Green Globes NC
Stage II Assessment
Prairie Medical Building
Grayslake, Illinois

*New Construction
Stage II Assessment*

Subject: Green Globes Stage II Assessment for New Construction
Prairie Medical Building
180 South Highway 45
Grayslake, Illinois, 60030

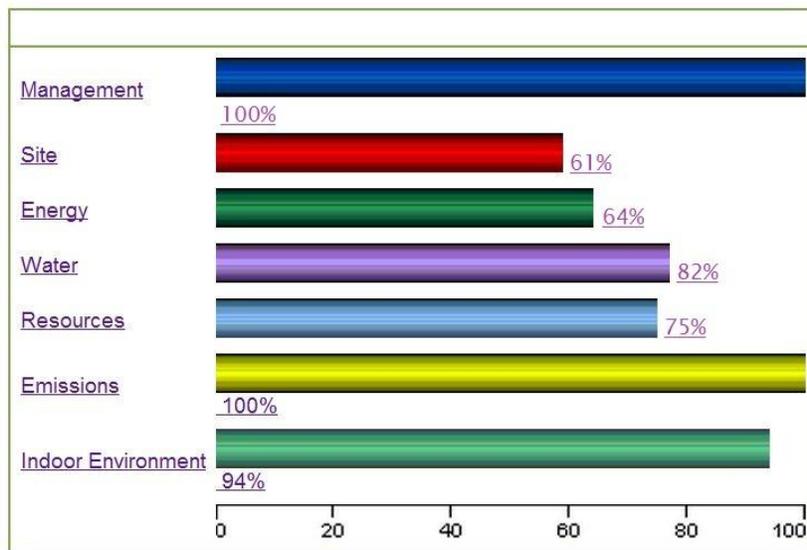
The breakdown of scoring for each of the six sections used to assess the building is shown in the chart at right. Green Globes online tools create this summary as part of a recommendation report that is generated upon completion of the questionnaire.
